# Fire Risk Assessment

Property assessed: Kodak Court C Nightingale Avenue  
London HA1 3GN

Client: Network Homes Ltd

FRA Inspection Date: 09/09/2020  
FRA Issued to Client: 21/10/2020  
FRA valid to: 21/10/2021  
FRA completed by: Savills (UK) Ltd,  
33 Margaret Street, London W1G 0JD  
T: 020 7409 8737  
E: [fireriskhousing@savills.com](mailto:fireriskhousing@savills.com)

Question - G.2: Are combustible items kept clear from sources of ignition such as electrical equipment? No

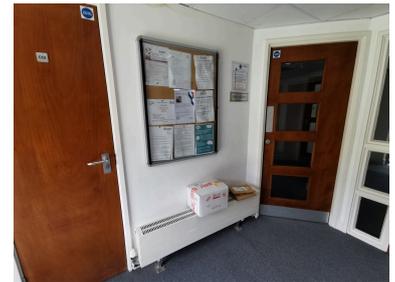
Comment: Combustible items were noted close to an ignition source. There were stored combustible materials including broken chairs and mattresses kept within the electrical intake cupboard (C06) There were plastic bags noted within bedroom riser cupboards within (018-024) within 123 and 225 bedroom riser cupboards. This issue should be dealt with as soon as possible.

Recommendation: All combustible items should be removed from the electrical intake cupboard as soon as possible and the door kept locked.

Question - M.5: Are common area fire door sets fitted with adequate self-closing devices where required? No

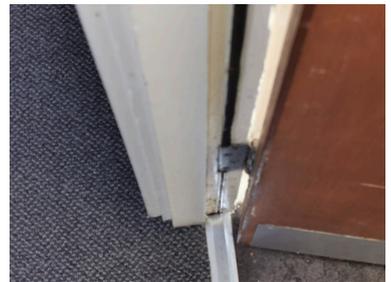
Comment: The cluster kitchen doors on the first floor (153), the 2nd floor (253) and the 3rd floor (354) are an ill fit in their frames and not effectively self-closing. See M2. In addition to the above doors noted in M2 - The electrical intake cupboard C06 and ground-floor stairwell doors are not fully closing into the frames. Management has confirmed that there is an ongoing programme of routine inspection being undertaken to all doors fitted within self-closing devices.

Recommendation: The self-closing device should be repaired or an effective self-closing device should be fitted to the doors as noted.

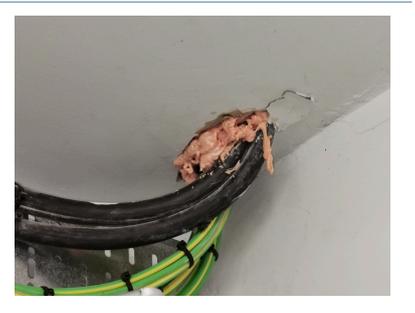
Comment: There were various compartmentation breaches noted throughout the escape route above the suspended ceilings adjacent to the bedroom riser cupboards. As previously recommended - an intrusive inspection should be undertaken throughout the communal areas (above suspended ceilings) and noted breaches fire-stopped to provide 60 minutes of fire-resistance. Breaches were noted above the suspended ceiling adjacent to the bedroom service riser cupboards on the ground floor within the lobby 018-024 and above 027's bedroom riser cupboard. First-floor: 119-124 - above bedroom riser cupboard 123. Second-floor: 219-224 - Above middle bedroom riser cupboards.

Recommendation: The compartmentation breaches noted within the voids above the false ceilings should be made good with appropriate fire-resisting materials/construction. Period of fire resistance required is 60 minutes.
